Note: Comment responses in Red added by FAHA 5/31/16 & Revised 6/10/16

Memorandum

Regarding: Storrs Lodge, LLC, Town of Mansfield Inland Wetland Application Review (PN: 1605880)

Date: May 12, 2016

SKETCH #1
 5/24/16

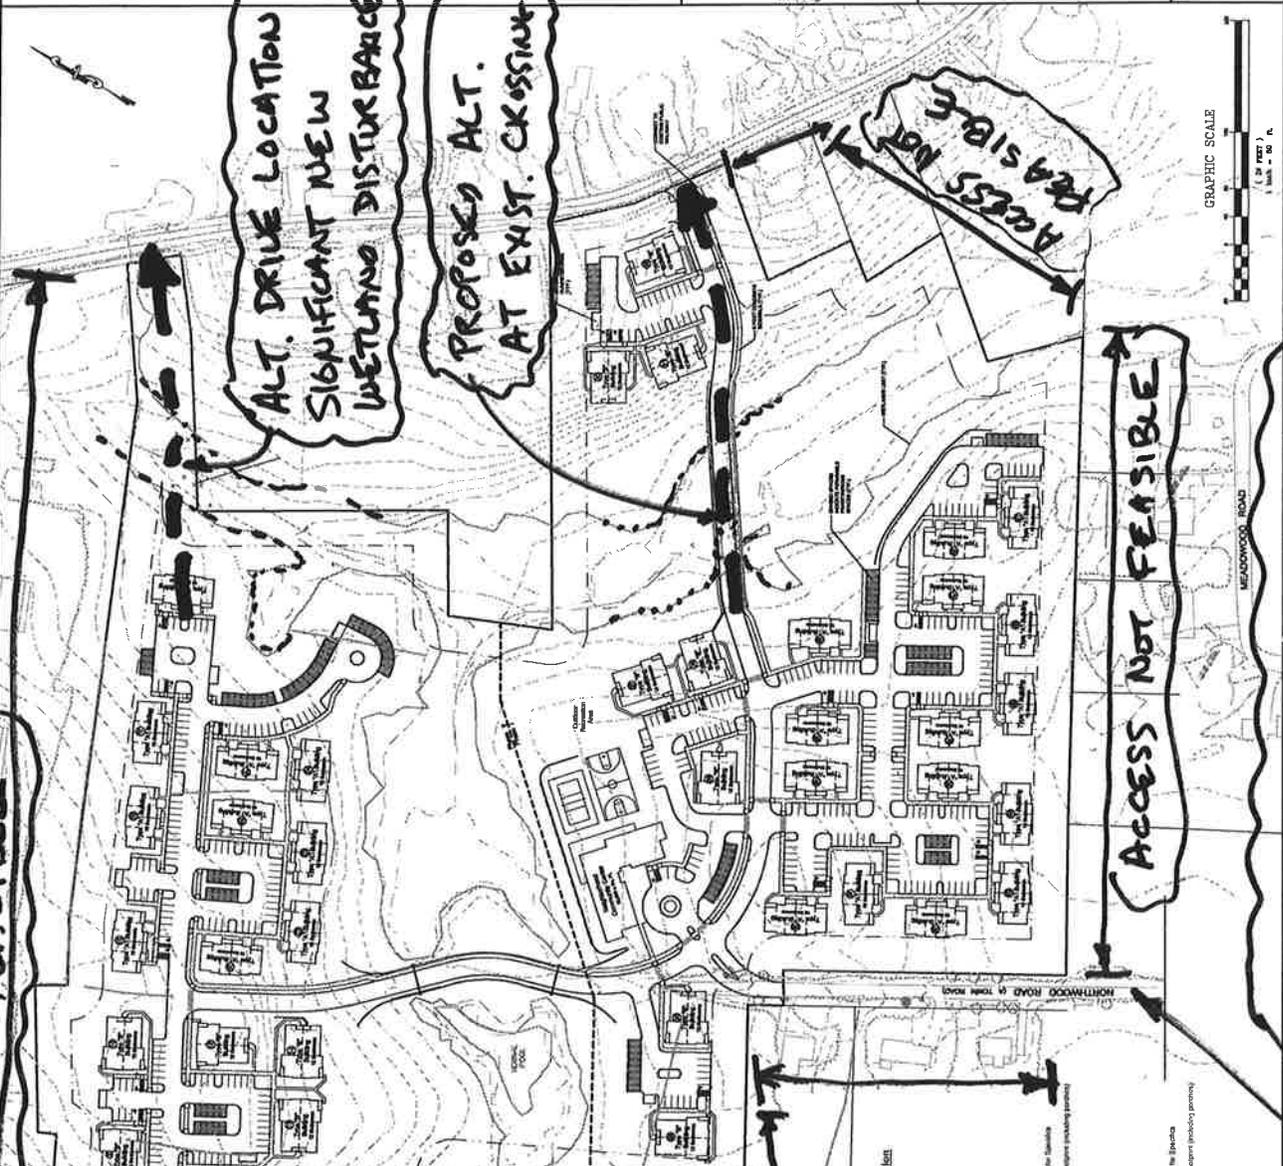
19. According to the Town of Mansfield Inland Wetlands and Watercourses Regulations Effective February 15, 2012) Section 7.4 G, the inland wetland application shall include, at a minimum “Alternatives which would cause less or no environmental impact to wetlands or watercourses and why the alternative requested in the application was chosen; all alternatives shall be diagramed on a site plan or drawing or otherwise described to the Agency’s satisfaction.” The application plans and reports do not provide an evaluation of feasible and prudent alternatives for the Site. The applicant should be able to provide an evaluation of an alternative for a main access road that would not require direct impact to wetlands. *Please refer to the Attachment provided to these comment responses regarding the alternatives evaluated in the design of the project.*

Given the topographical features of the property and practical access limitations to existing public roadways, any type of development on this property would include access roads and public utility connections basically following the layout included in the proposed project. It is the opinion of the applicant that there are no other feasible road locations on the property. See Sketch #1, attached.

Roadway access to the abutting apartment complex to the north is not feasible due to the layout of the existing housing units and parking areas within that complex. There is no feasible connection to the west due to topographic considerations and the presence of the State Forest land.

Relocating the proposed roadway access to Hunting Lodge Road further to the north would require construction of a new roadway crossing through a significant undisturbed wetland corridor. There is no evidence to suggest that such a crossing has existed in the past at this location. Undertaking such a crossing is not considered to be prudent when compared to the proposed crossing location.

Roadway access to the south can only occur by extending Northwood Drive since the project site is abutted along the southerly boundary by an existing residential subdivision. Northwood Road begins at North Eagleville Road as basically a parking lot driveway to provide access to a student apartment complex owned and operated by the University. Head-in 90-degree parking is constructed along both sides of the first 800 l.f. of roadway along with painted raised pedestrian crossings and screened dumpster locations. From there, the roadway continues as a minor town road to service the three existing residential lots at the north end of the road.

ACCESS NOT FEASIBLE

ALT. DRIVE LOCATION
 SIGNIFICANT NEW
 WETLAND DISTURBANCE

PROPOSED ACT.
 AT EXIST. CROSSING

SINGLE PAVICIT
 ACCESS
 TO NORTHWOOD NOT PRUDENT

ACCESS TO
 WEST NOT
 FEASIBLE
